| REV# | DWN BY | DESCRIPTION | DATE |
|---|---|---|---|
| A | GSV | ISSUED FOR APPROVAL | May 27 2025 |

PROJECT DESCRIPTION : CLEVELAND BROTHERS-MILESBURG

DWG DESCRIPTION : SECTION & ELEVATION

## 1 EM07 ELEVATION

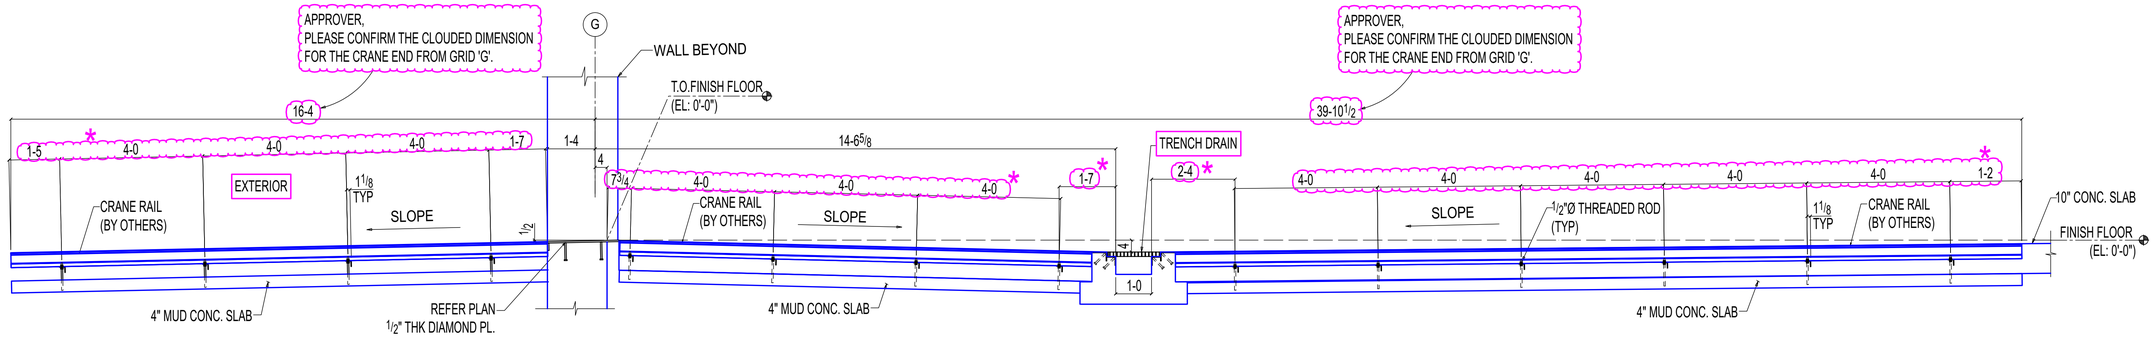
APPROVER,
* -PLEASE CONFIRM CLOUDED CRANE RAIL
SUPPORT ANGLE LOCATIONS ARE OK TO PROCEED?.

## 2 EM07 SECTION

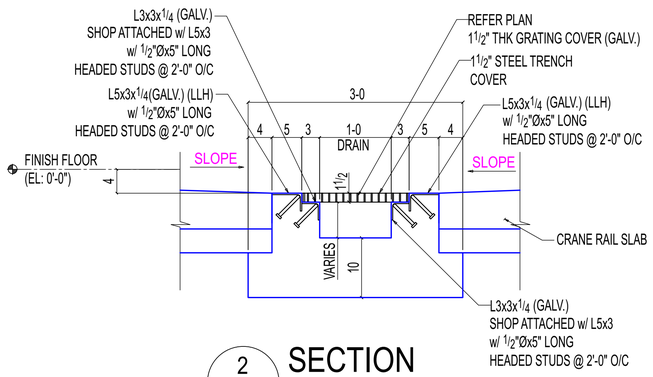
APPROVER,
# - PLEASE CONFIRM ANGLE EXTENSION
FROM CENTER OF RAIL.

APPROVER,
PLEASE CONFIRM CLOUDED
THREADED ROD LOCATION FROM
CENTER OF CRANE.

## 3 EM07 SECTION

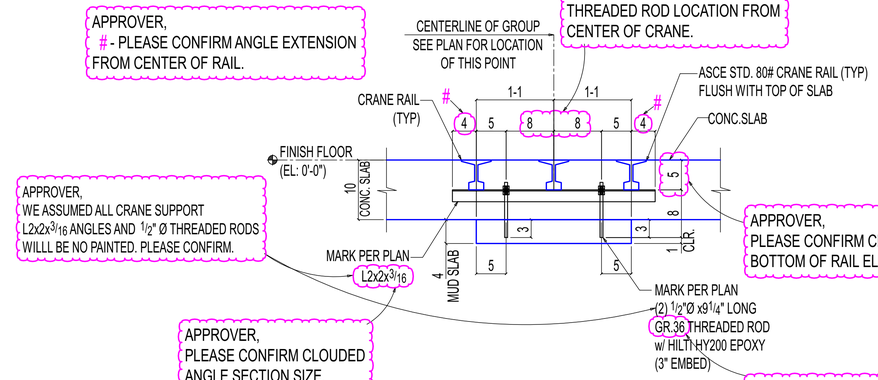
APPROVER,
WE ASSUMED ALL CRANE SUPPORT
L2x2x3/16 ANGLES AND 1/2" Ø THREADED RODS
WILLL BE NO PAINTED. PLEASE CONFIRM.

APPROVER,
PLEASE CONFIRM CLOUDED
BOTTOM OF RAIL ELEVATION.

APPROVER,
PLEASE CONFIRM CLOUDED
ANGLE SECTION SIZE.

APPROVER,
PLEASE CONFIRM CLOUDED THREADED ROD GRADE.

## 4 EM07 SECTION

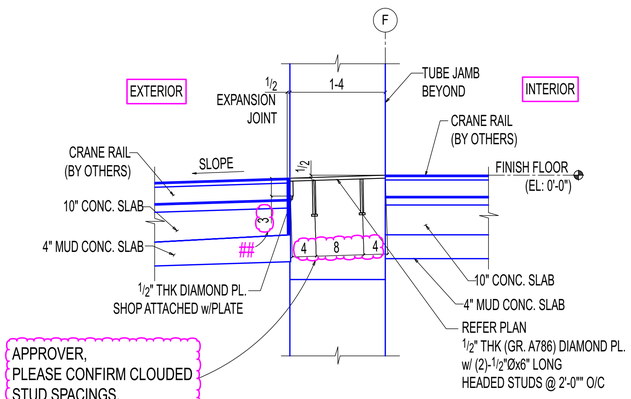
APPROVER,
PLEASE CONFIRM CLOUDED
STUD SPACINGS.

APPROVER,
PLEASE CONFIRM CLOUDED
EMBED PLATE LENGTH IS ACCEPTABLE.

## 5 EM07 SECTION

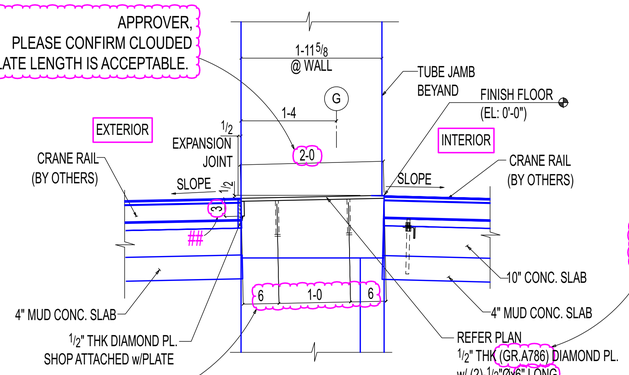
APPROVER,
PLEASE CONFIRM DIAMOND PLATE GRADE IS OK TO PROCEED?

APPROVER,
PLEASE CONFIRM CLOUDED STUD
SPACINGS ARE OK TO PROCEED?

APPROVER,
THE STRUCTURAL DRAWING 10/S400 INDICATES 6" LONG STUD,
WHILE ARCH SHEET S-2/A518 SHOWS 3" FOR THE SAME.
WE INTEND TO FOLLOW THE 6" LENGTH AS PER THE STRUCTURAL DRAWING.
PLEASE CONFIRM IF THIS IS ACCEPTABLE.

APPROVER,
## -PLEASE CONFIRM CLOUDED DIAMOND PLATE VERTICAL LEG.
